**SD 15 22 FED COM P404
(404H, 303H, 405H, 406H,
304H) [fJMB2232539215]**

**C-144/ Permit Approval
with Conditions**

SD 15 22 FED COM P404 (404H, 303H, 405H, 406H, 304H) [fJMB2232539215]
Temporary Pit non-low chloride fluids. Approval with Conditions.

NMOCD has reviewed [4323] CHEVRON USA INC, Application and Form C-144 received on November 16, 2022, for the proposed SD 15 22 FED COM P404 (404H, 303H, 405H, 406H, 304H) [fJMB2232539215], Temporary Pit in Unit Letter B, Section 15, Township 26S, Range 32E, Lea County, New Mexico.

Appendix D – Design Plan

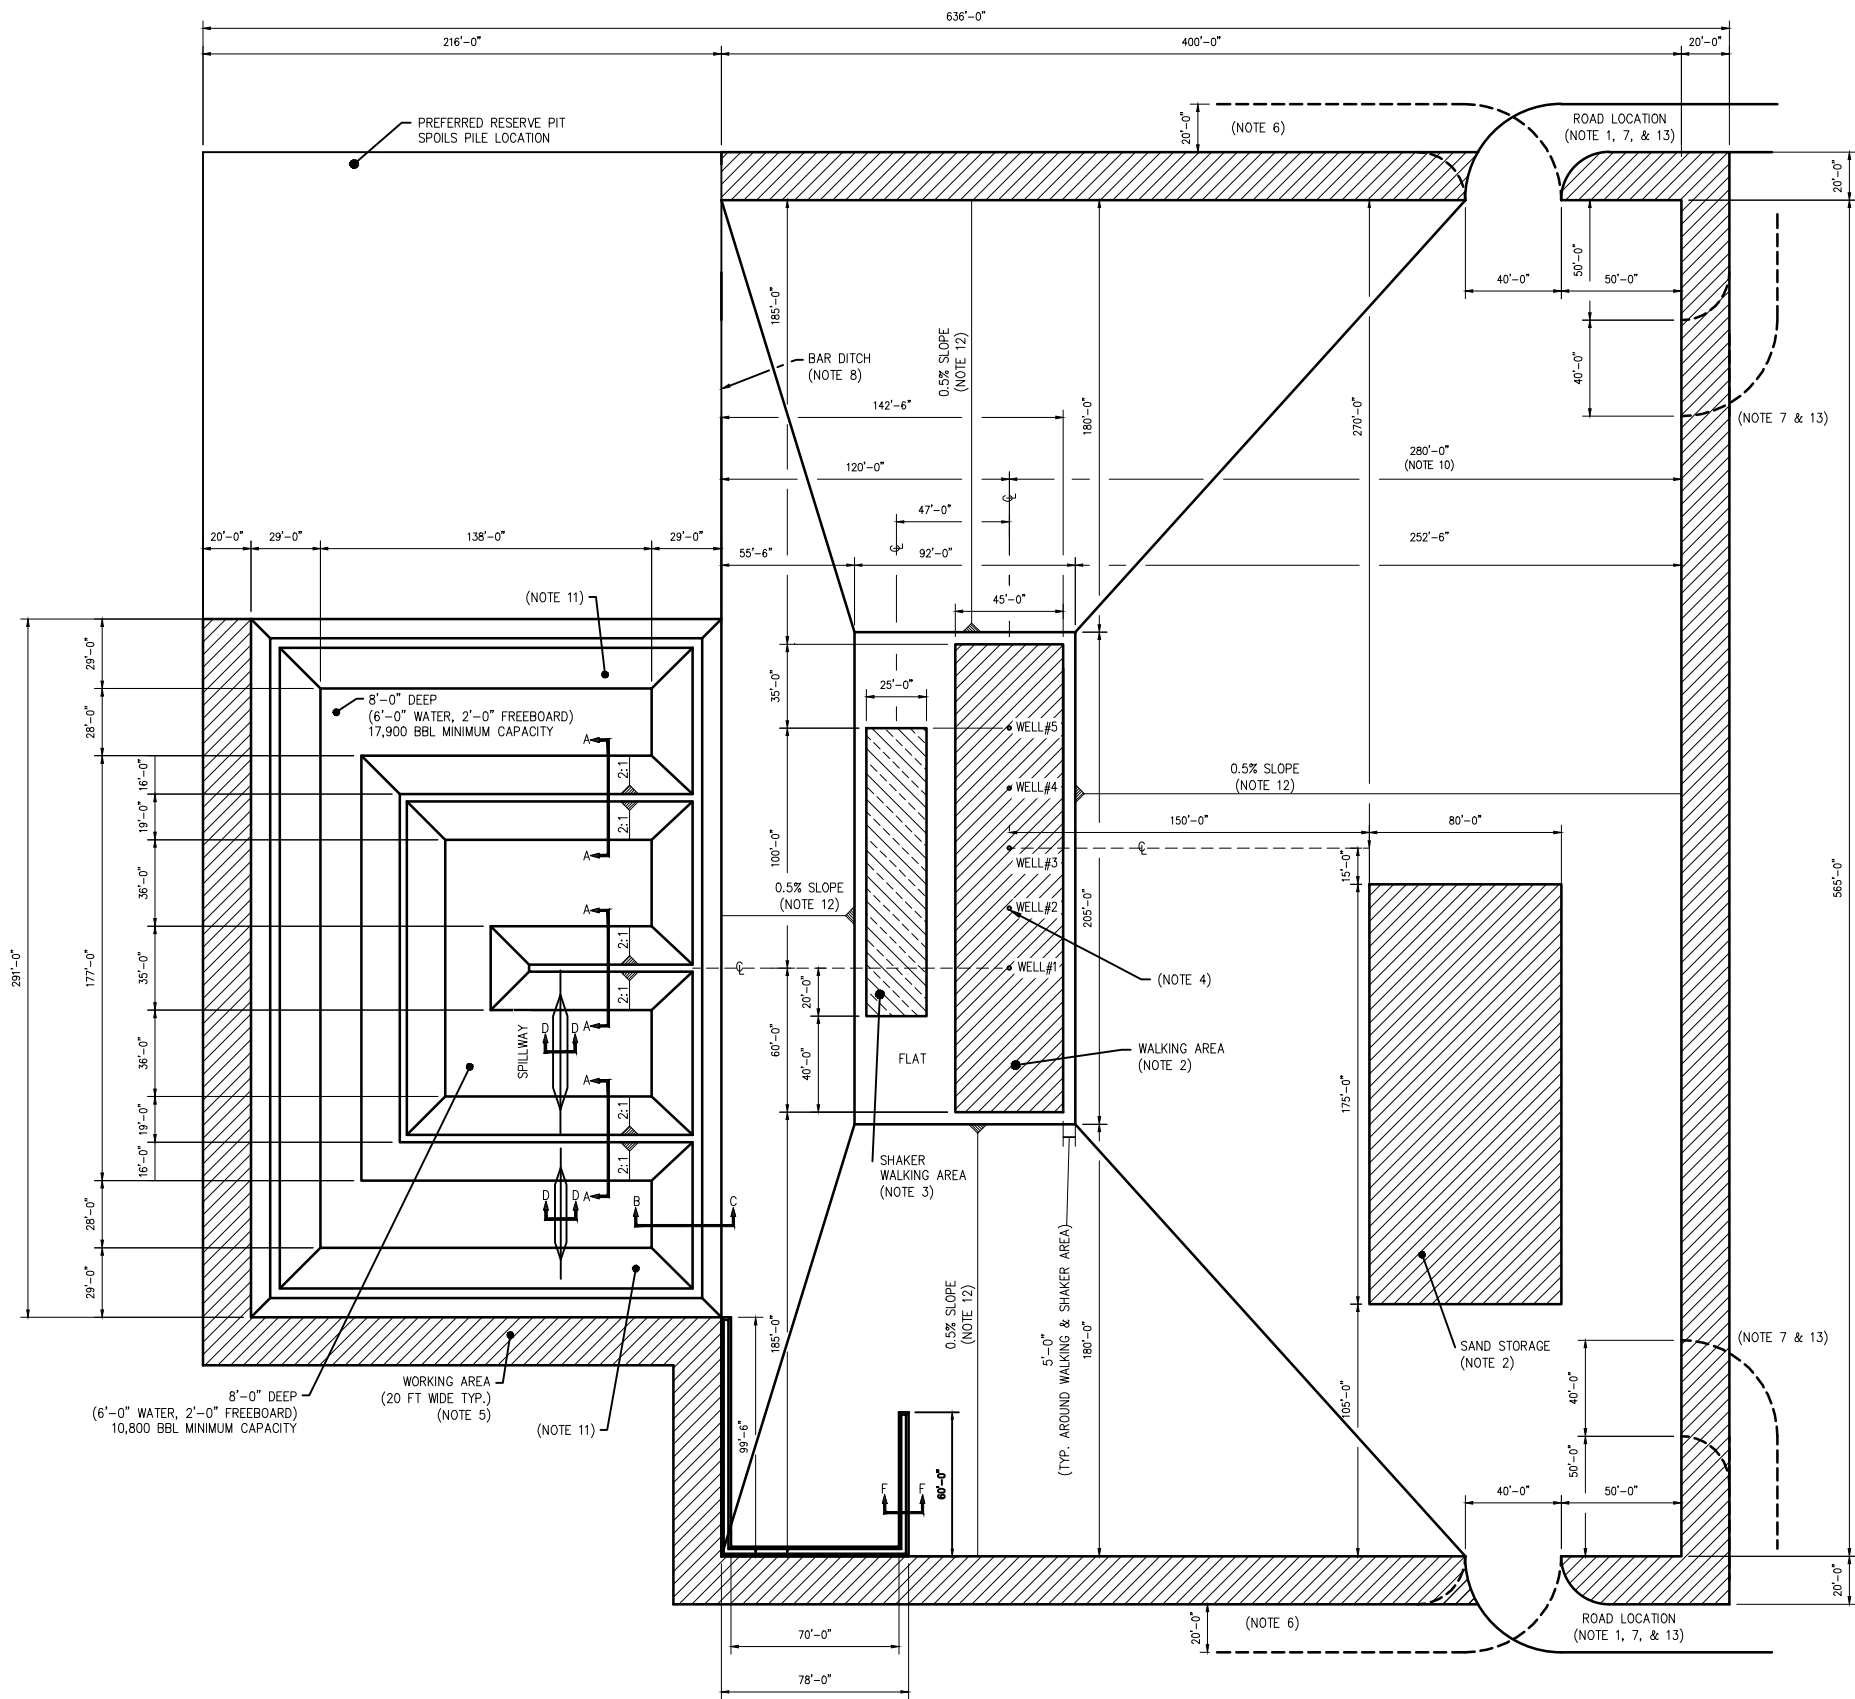
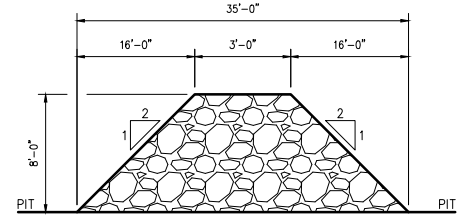
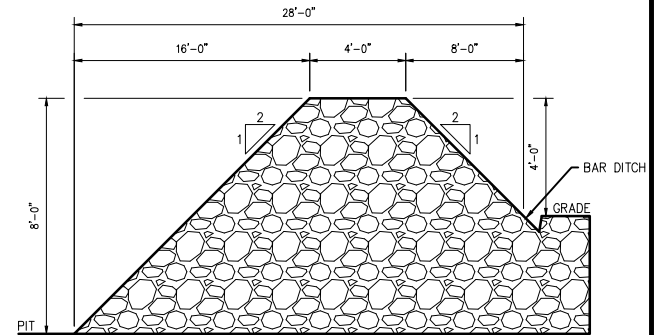
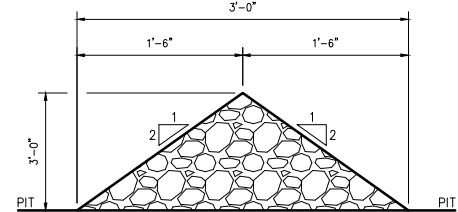
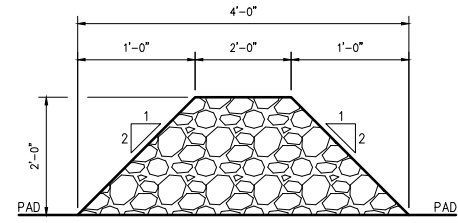
4. The design and construction plan, included as Appendix D of the Application, is approved. [4323] CHEVRON USA INC shall design and construct SD 15 22 FED COM P404 (404H, 303H, 405H, 406H, 304H) [fJMB2232539215] Pit as described in the approved plan. [4323] CHEVRON USA INC shall apply for a permit modification for any change to the plan.
